Gibbons Creek Environmental Redevelopment Group, LLC

September 6, 2022

Re: Technical NOD2 New CCR Registration  
Gibbons Creek Environmental Redevelopment Group, LLC – Anderson, Grimes County  
New Coal Combustion Residuals (CCR) Registration No. CCR113  
Industrial Solid Waste Registration No. 32271  
EPA Identification No. TXD000751073  
Tracking No. 27262344; RN100214550/CN6505860162

REVISED TABLE IV.D LANDFILL INSPECTION

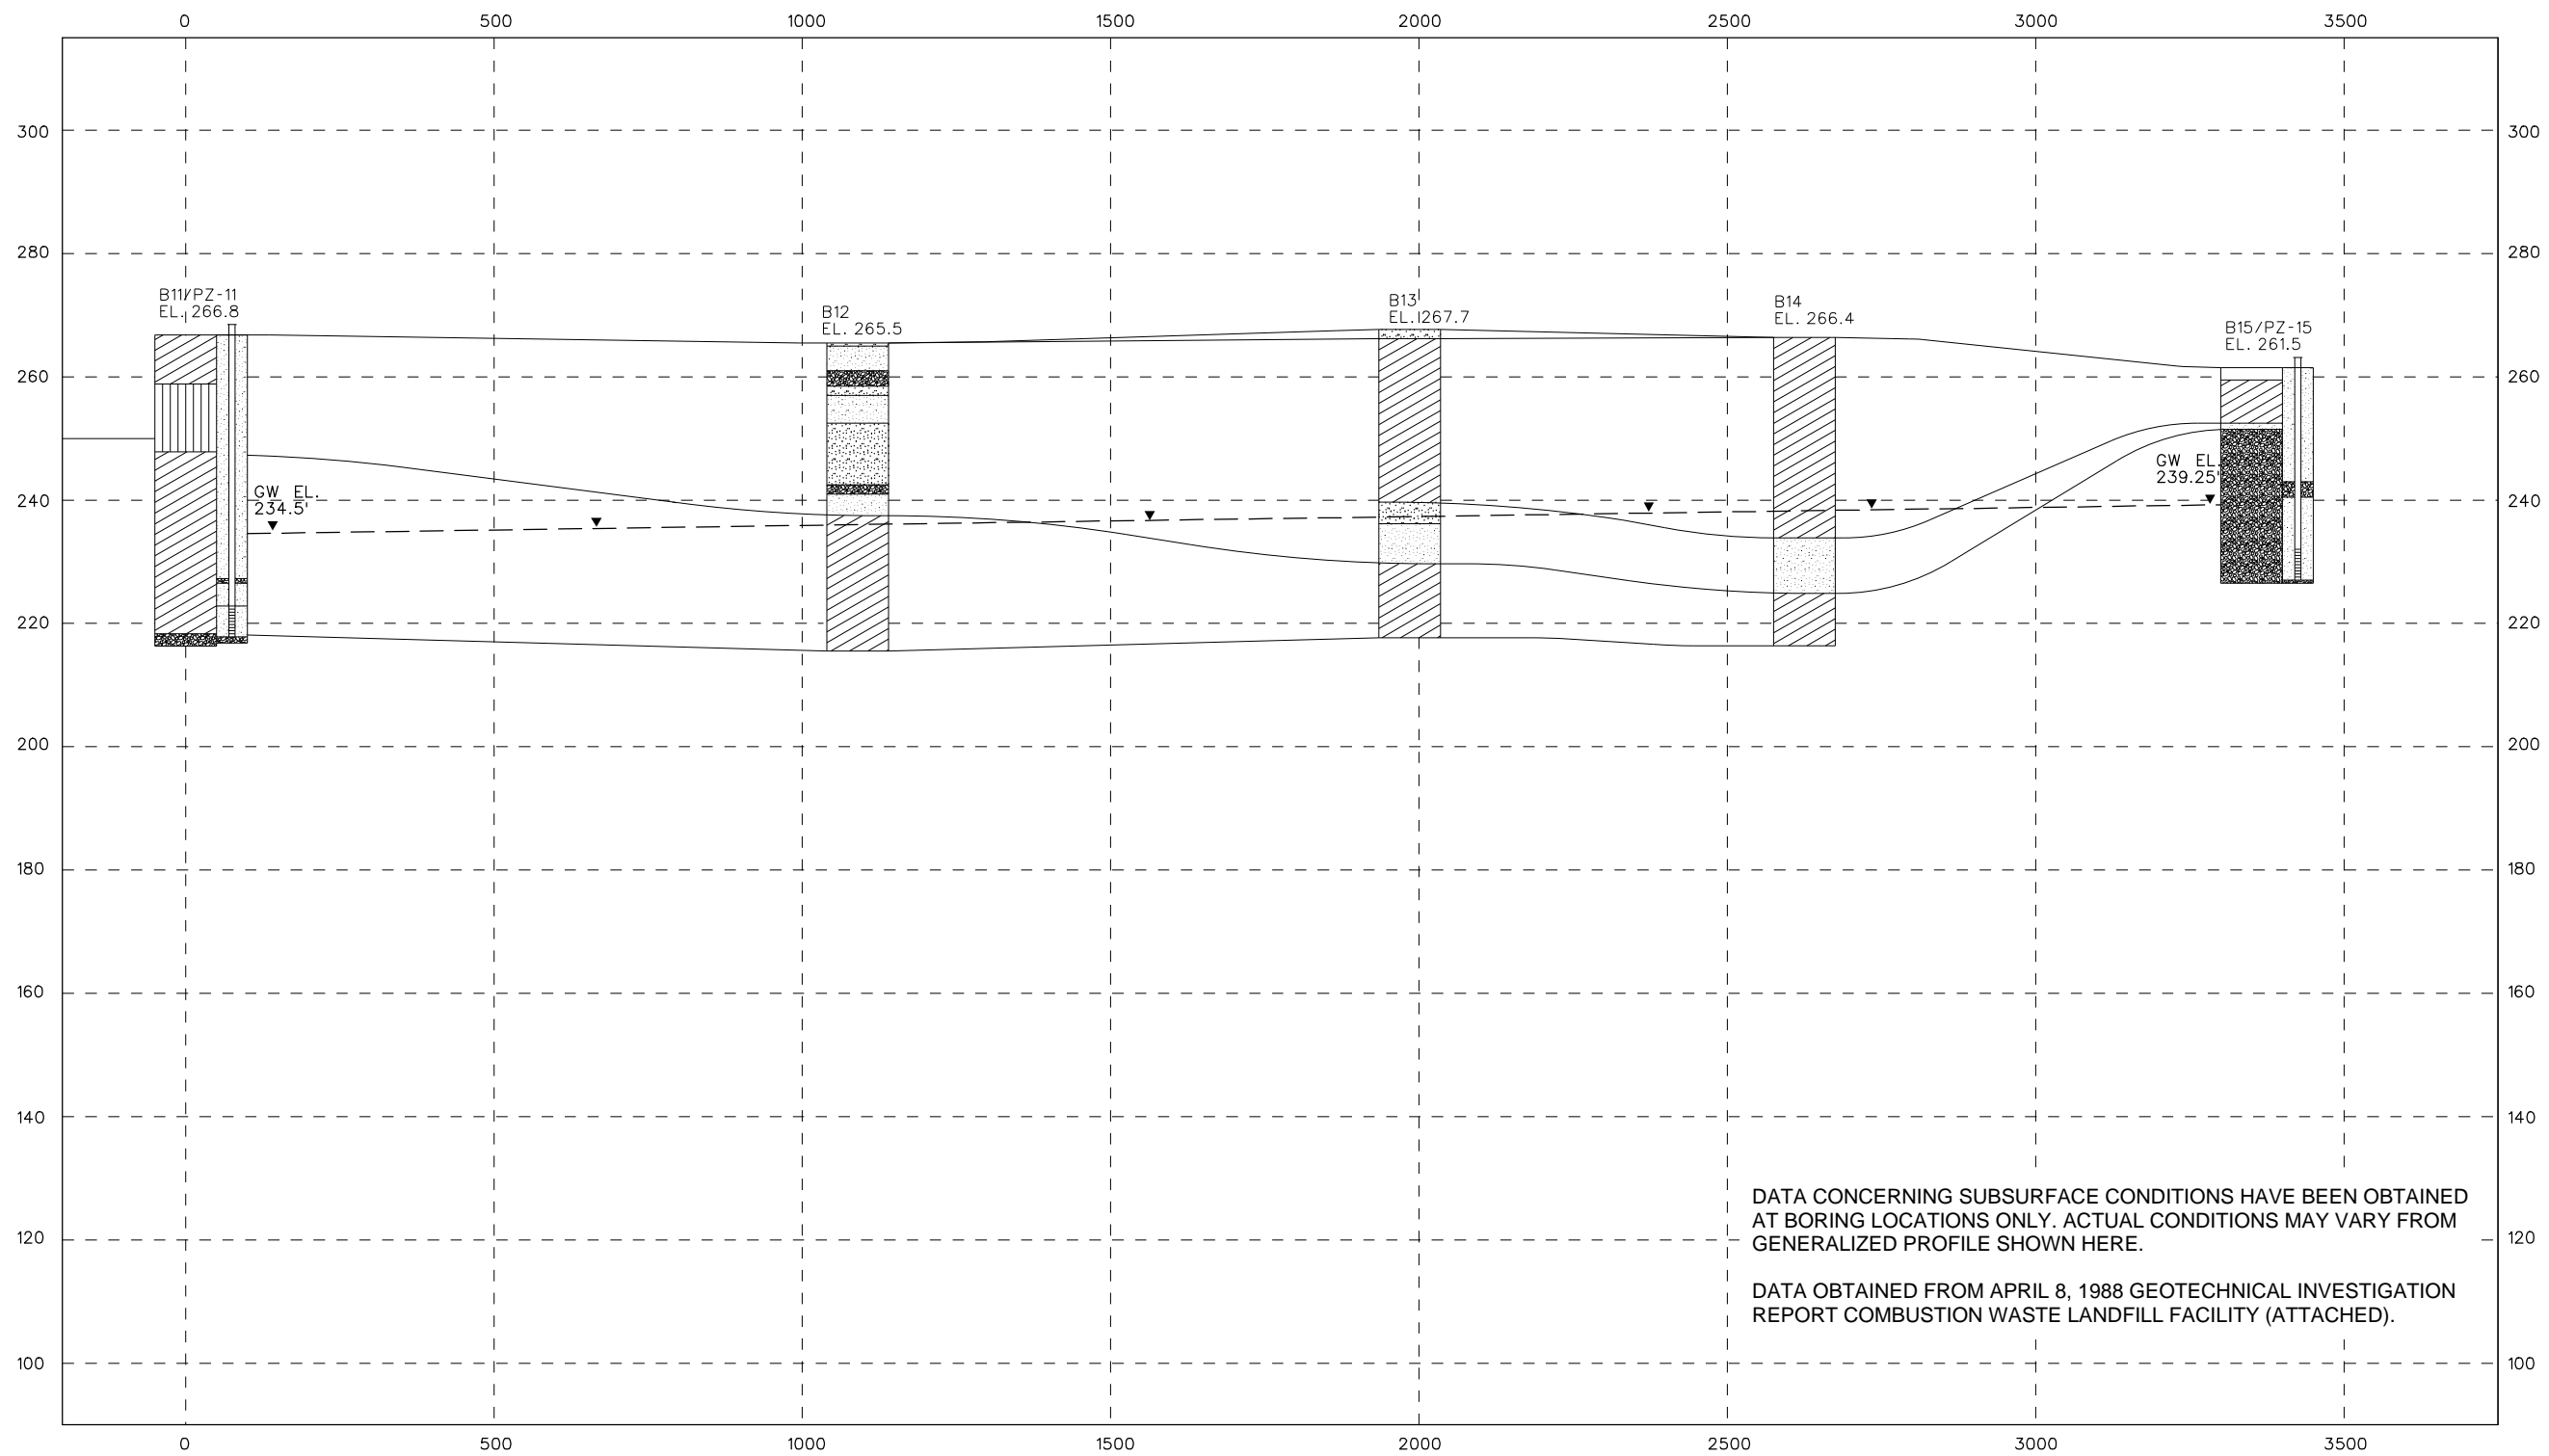
**16. Table IV.D (Att. M)**

Include facility unit(s) and specify all landfill components and basic elements for inspections to match with the 2021 Site F Landfill annual inspection report (Att. M). Additionally, correct inspection intervals to “not exceeding seven days” from weekly.

*The revised Table IV.D can be found in Attachment Respond Item 16.*

RESPONSE ITEM 21  
ATTACHMENT

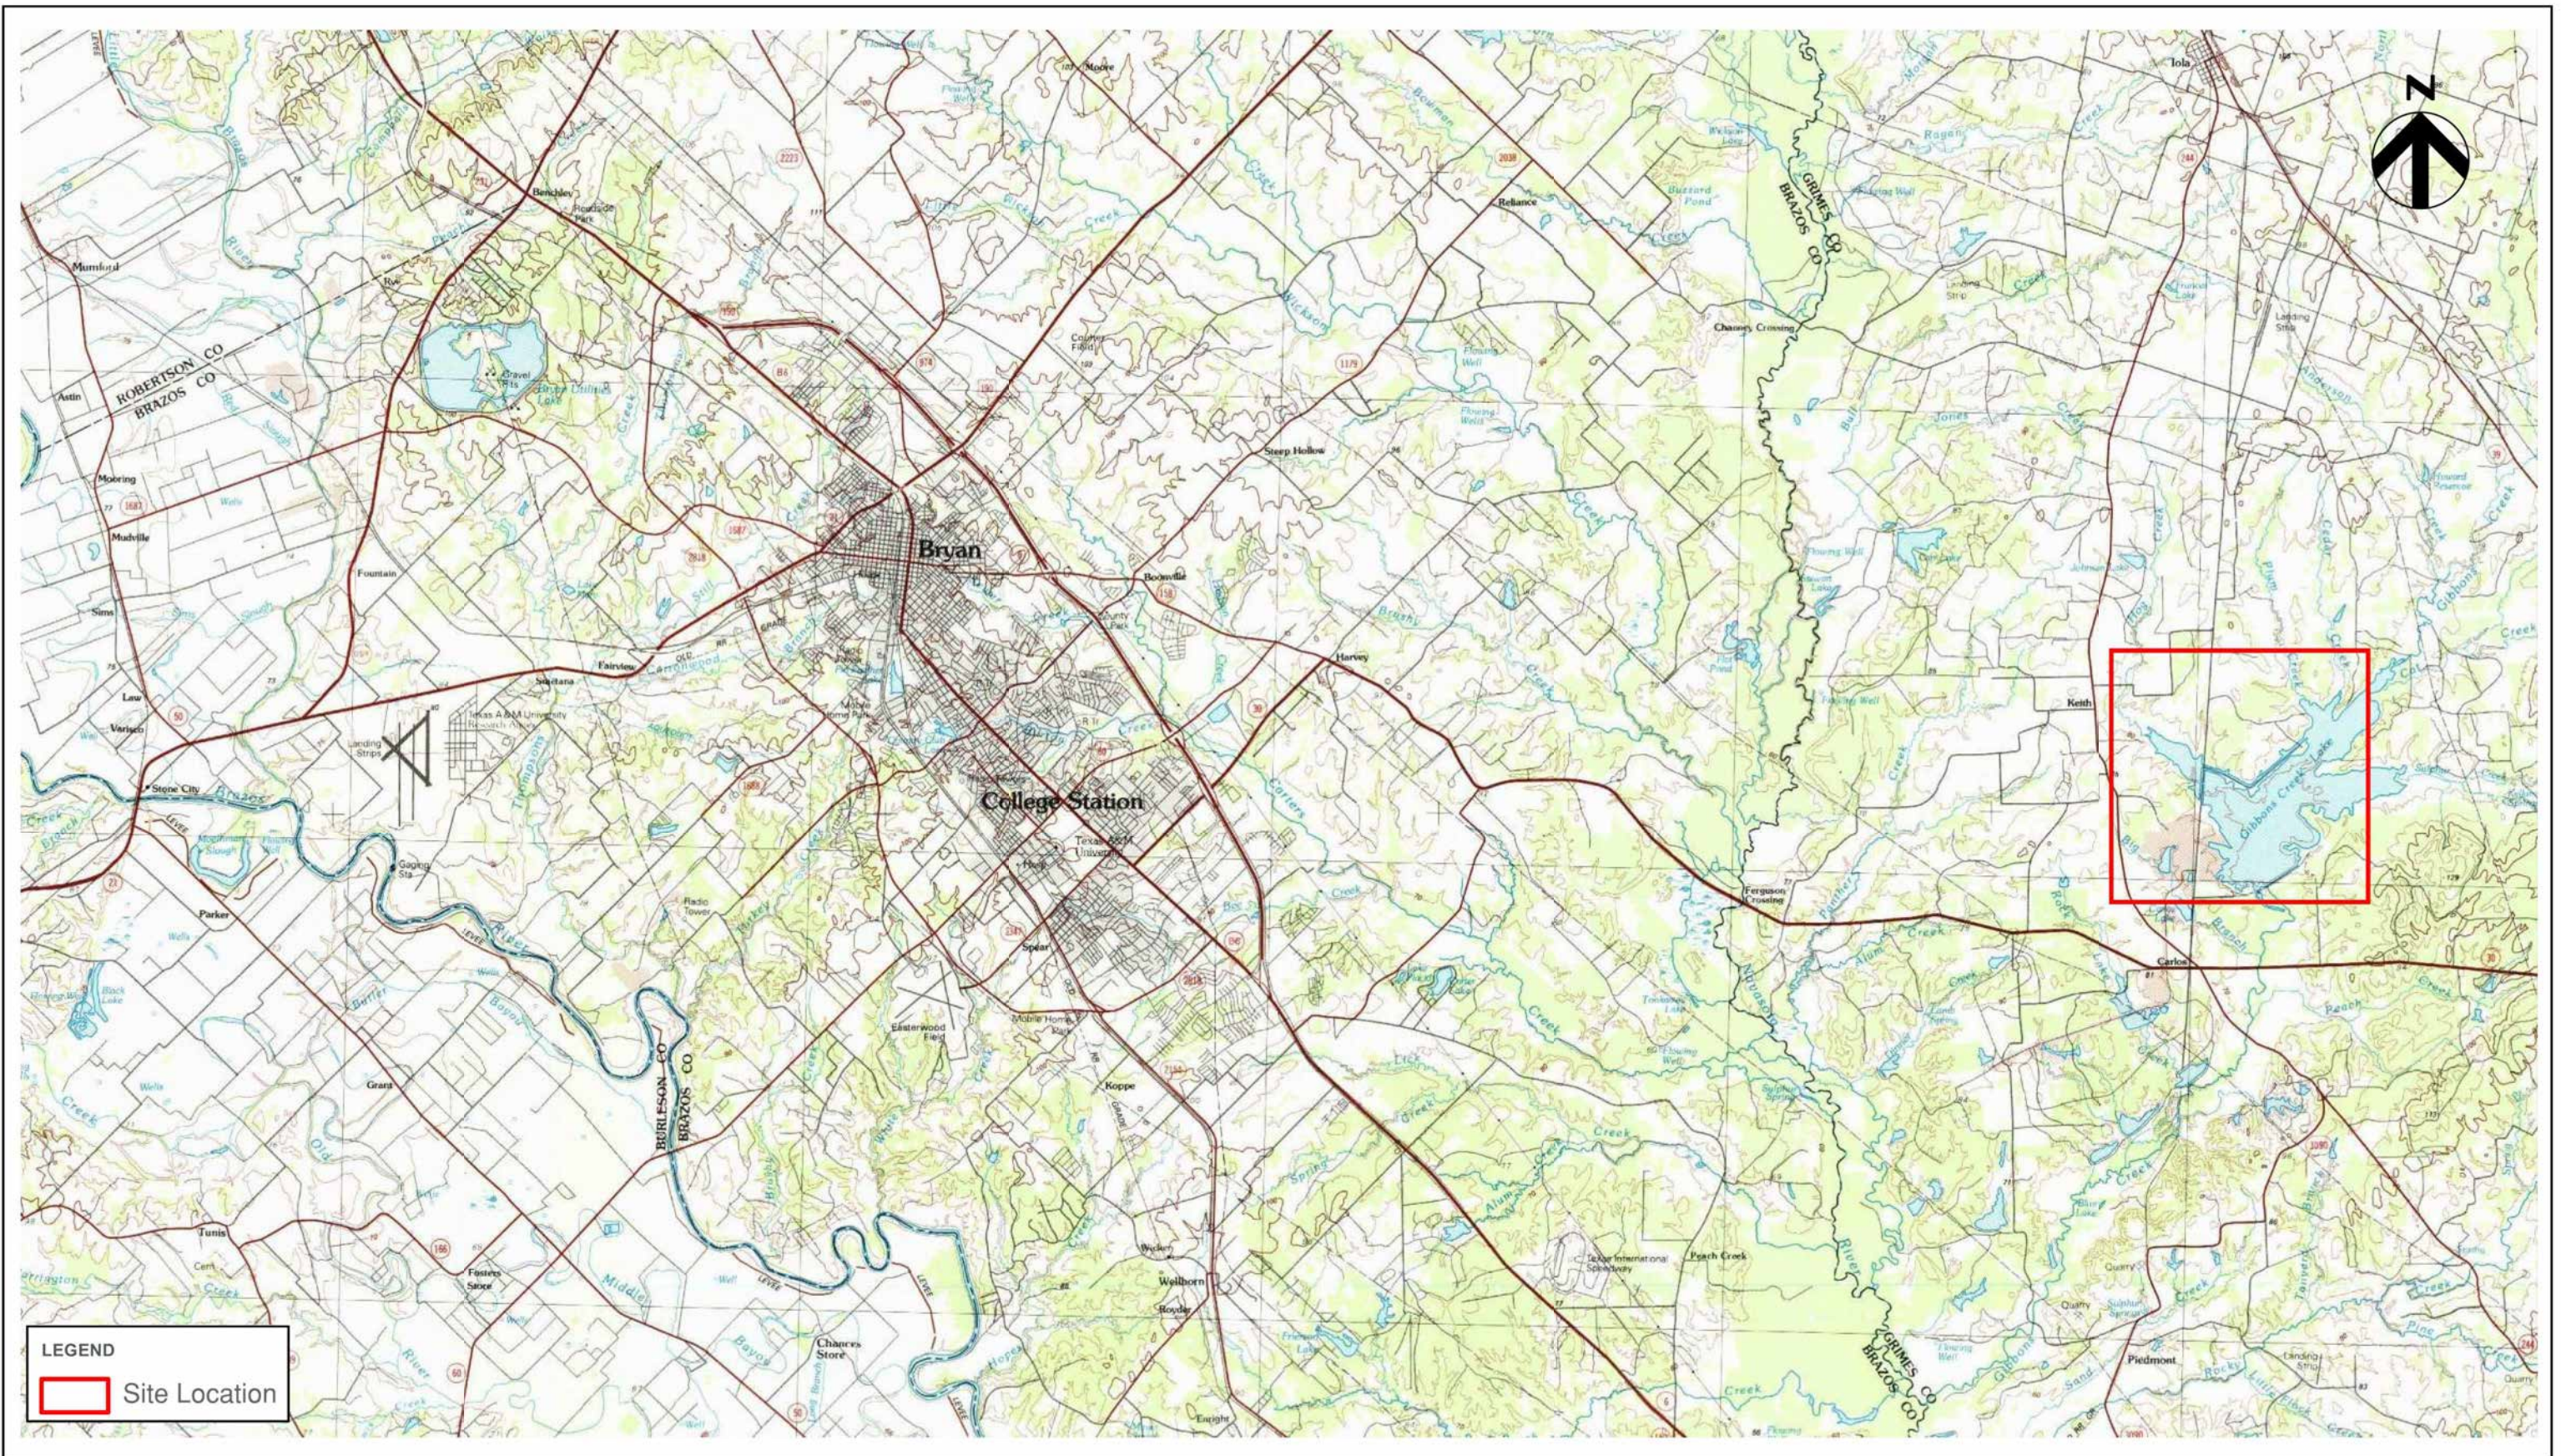
**21. 2021 Groundwater (GW) Report**

Provide historical data since the groundwater levels (ft amsl) are inconsistent with the aquifer report.

*See Response Item 21 Attachment for historical groundwater levels from 2018 through 2021.*
